Appendix I of RNTPC Paper No. A/YL-PH/1036

# UNDER SECTION 16 OF THE TOWN PLANNING ORDINANCE

劃資料查詢處供一般參閱。)
Application No. 申請編號	(For Official Use Only) (請勿填寫此欄)
Location/address 位置/地址	新界元朗八鄉七星崗DD110 LOT NO. 247(部份), 249, 250(部份), 251S.A RP(部份), 251S.B(部份), 262(部份), 263S.A&S.B&S.C(部份), 264(部份), 265, 266(部份), 267(部份), 269(部份), 269(部份), 270S.E(部份), 272, 273S.A, 273S.B, 274, 275, 276RP(部份), 277, 278, 279S.A, 279S.B, , 280, 281(部份), 285, 286, 287, 295, 299
Site area 地盤面積	30211 sq. m 平方米口 About 約
	(includes Government land of 包括政府土地 N/A sq. m 平方米 □ About 約)
Plan 圖則	S/YL-PH/11
Zoning 地帶	農業
Type of Application 申請類別	<ul> <li>✓ Temporary Use/Development in Rural Areas or Regulated Areas for a Period of 位於鄉郊地區或受規管地區的臨時用途/發展為期</li> <li>✓Year(s) 年3 □ Month(s) 月</li> <li>□ Renewal of Planning Approval for Temporary Use/Development in Rural Areas or Regulated Areas for a Period of 位於鄉郊地區或受規管地區臨時用途/發展的規劃許可續期為期</li> </ul>
	□ Year(s) 年 □ Month(s) 月
Applied use/ development 申請用途/發展	擬議臨時貨倉(危險品倉庫除外)及露天存放建築機械和建築材 料連附屬設施(為期3年)及相關填土工程

#### **Response to Comment**

Landscape Master Plan

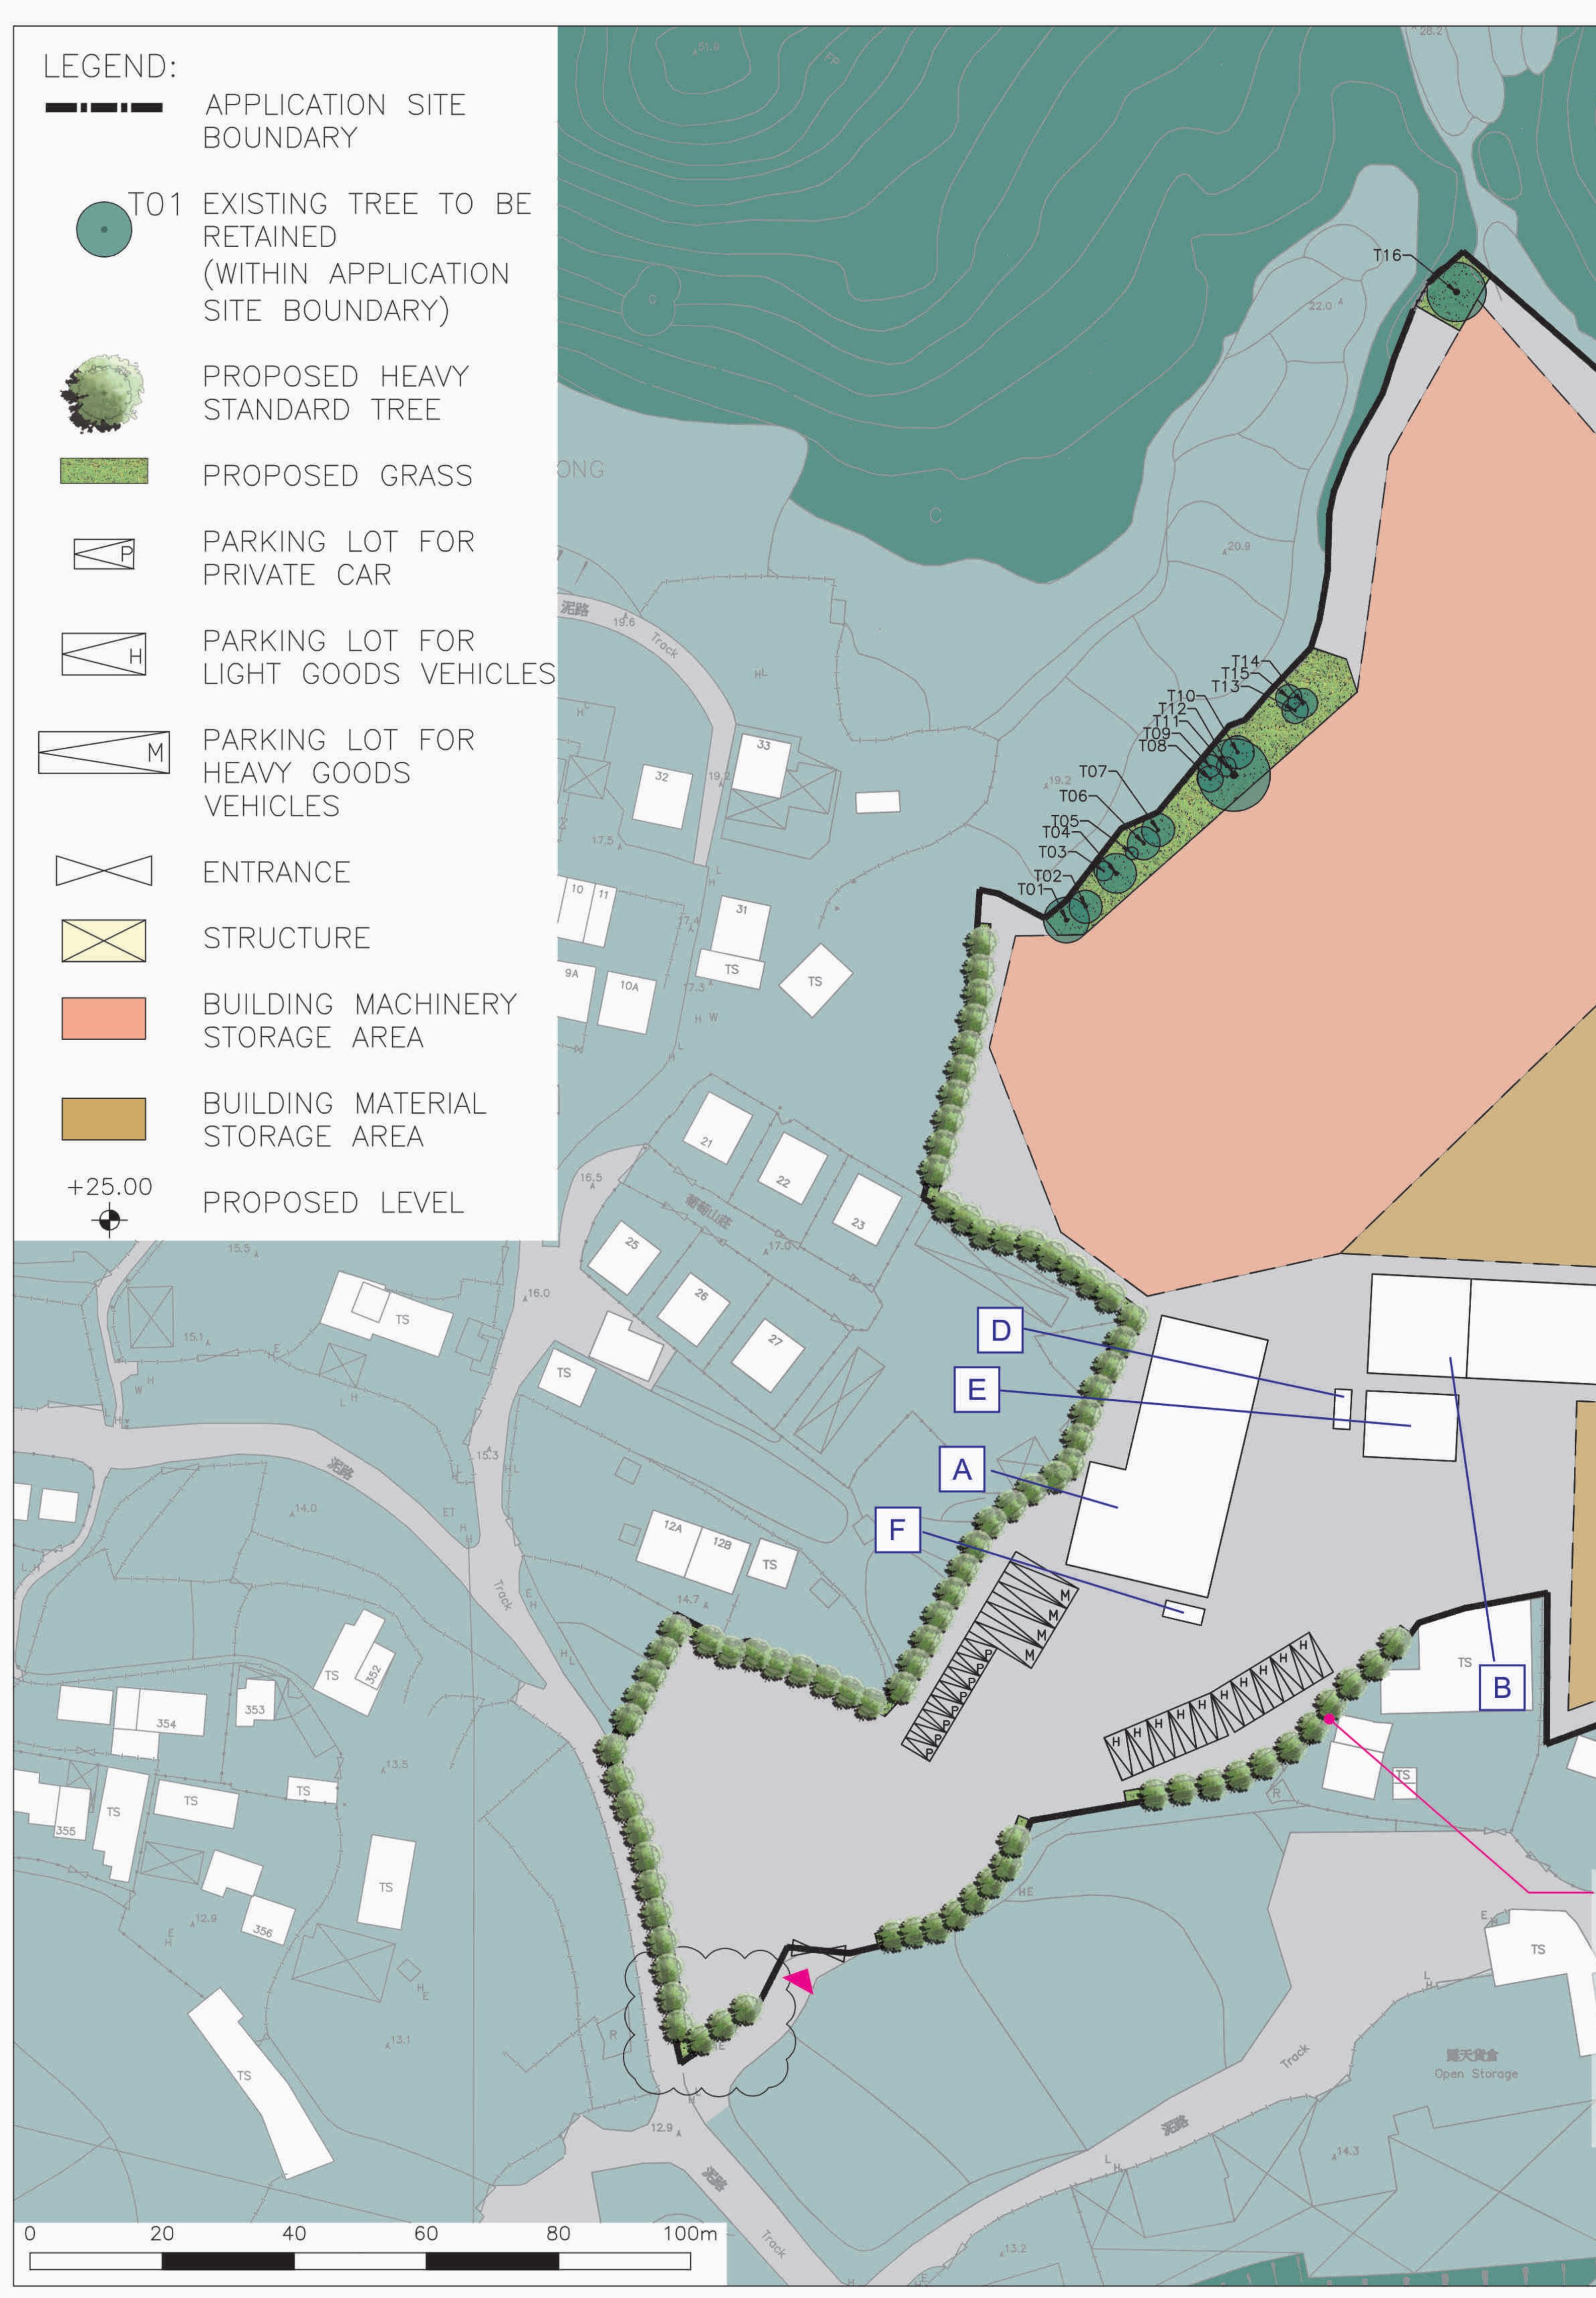
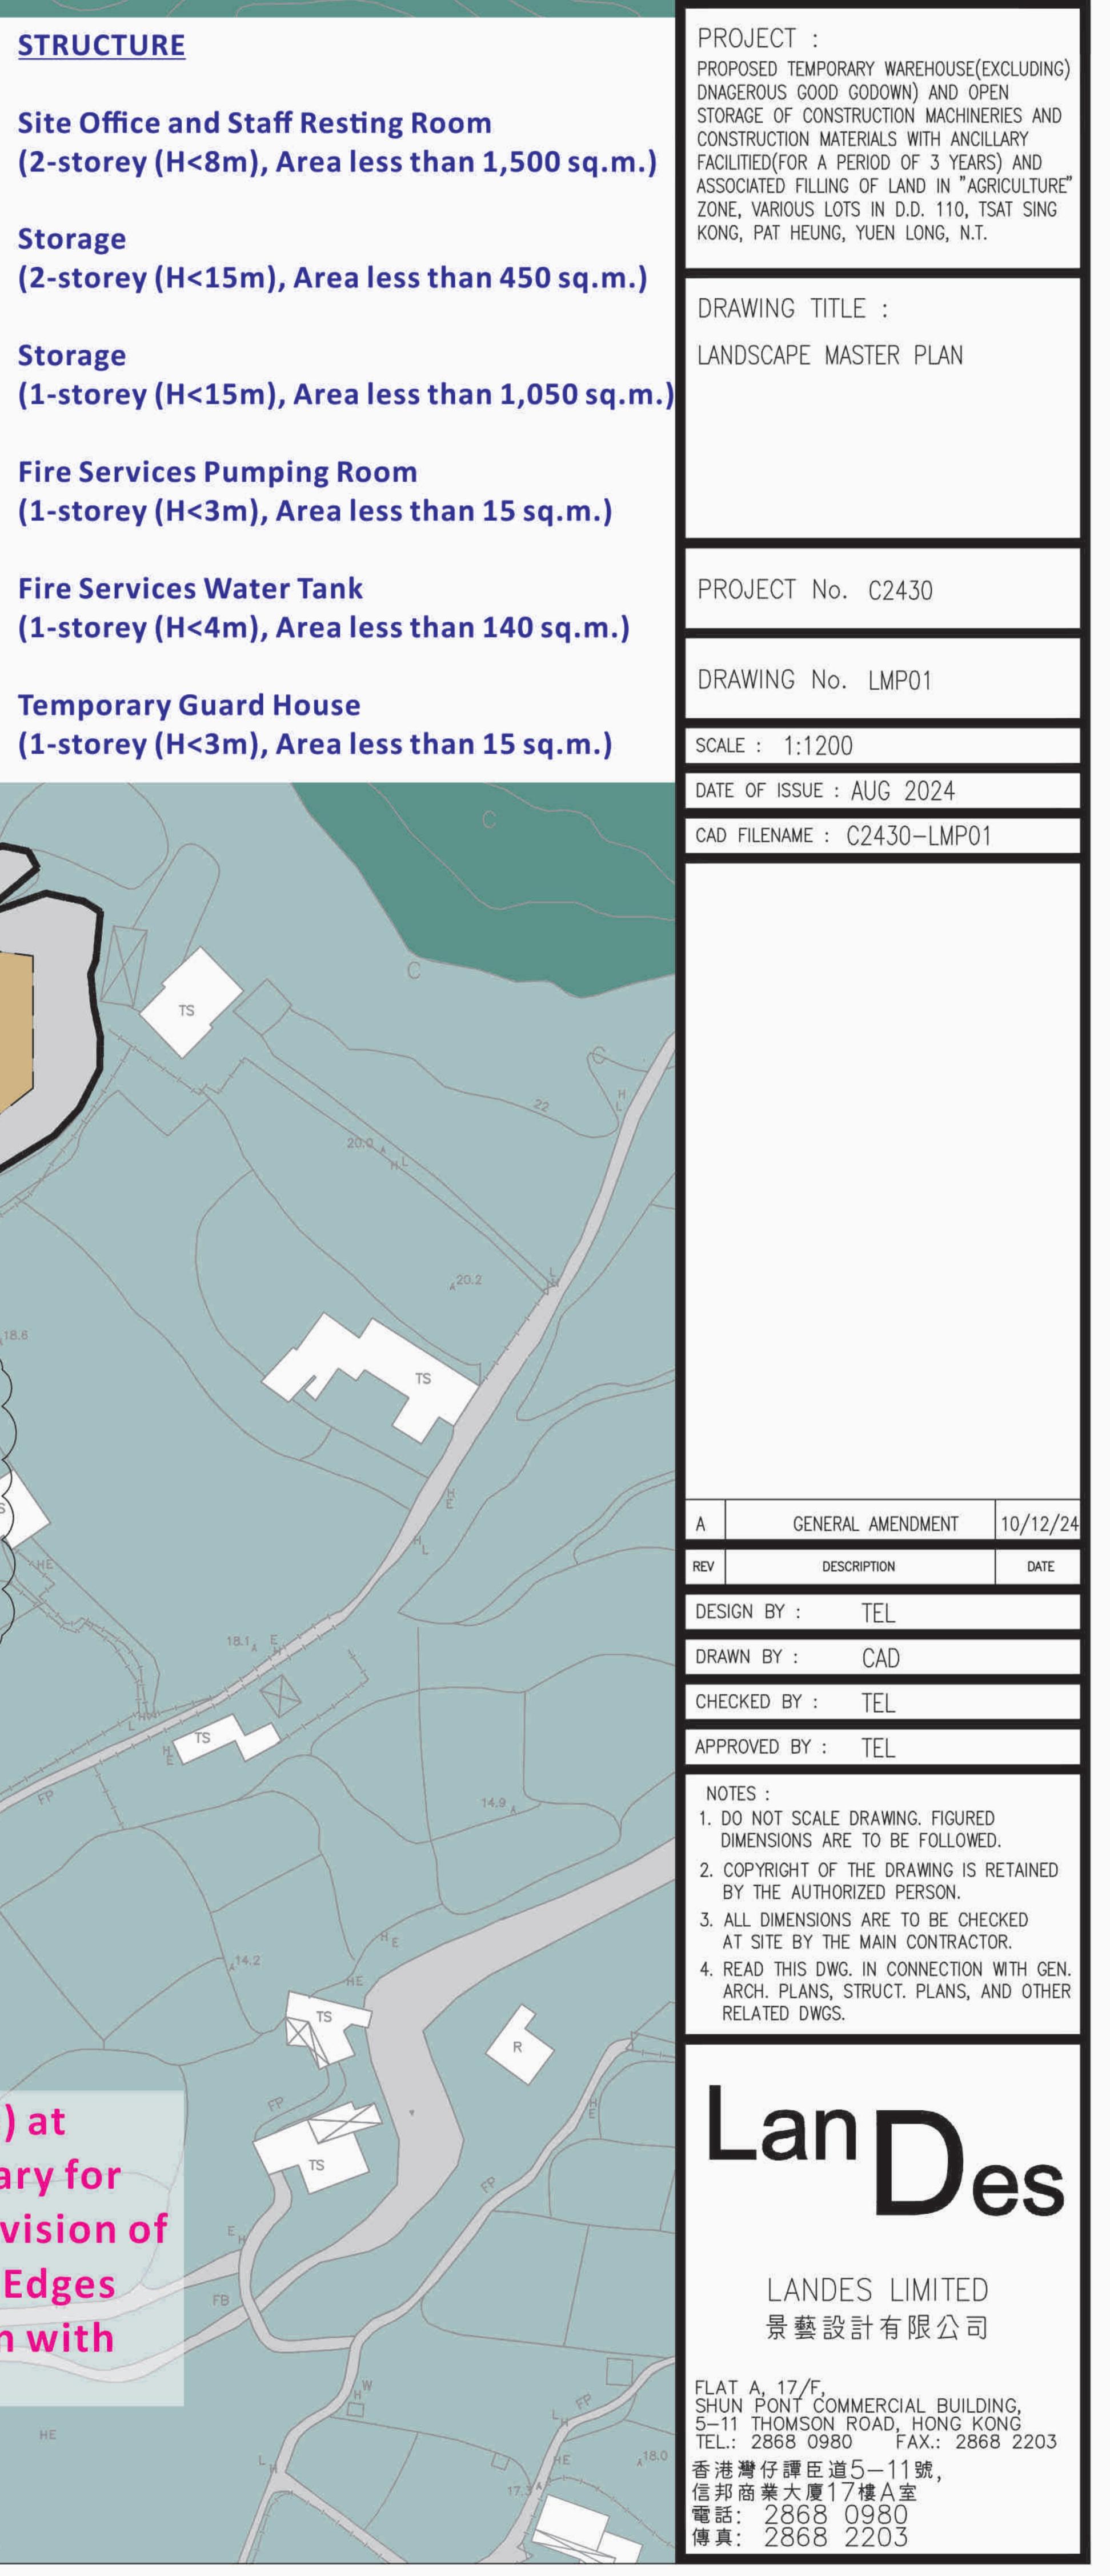
/ New tree planting	(N.B. paras 5.1.4 and 6.4 of the TPLP stated that 40 trees are proposed.)	
Re Drawing No. CP01, the applicant is advised to plant new trees at vacant areas along the east boundary of the Site (i.e. between proposed storage areas and metal fence) to enhance the greenery.		Noted. Additional trees are proposed at vacant areas along the east boundary, as shown on dwg. no. <b>CP01</b> .
3) The applicant is advised that approval of the application does not imply approval of tree works, if any, such as pruning, transplanting and felling. Application for any tree works should be submitted direct to relevant authorities) for approval.		Noted.
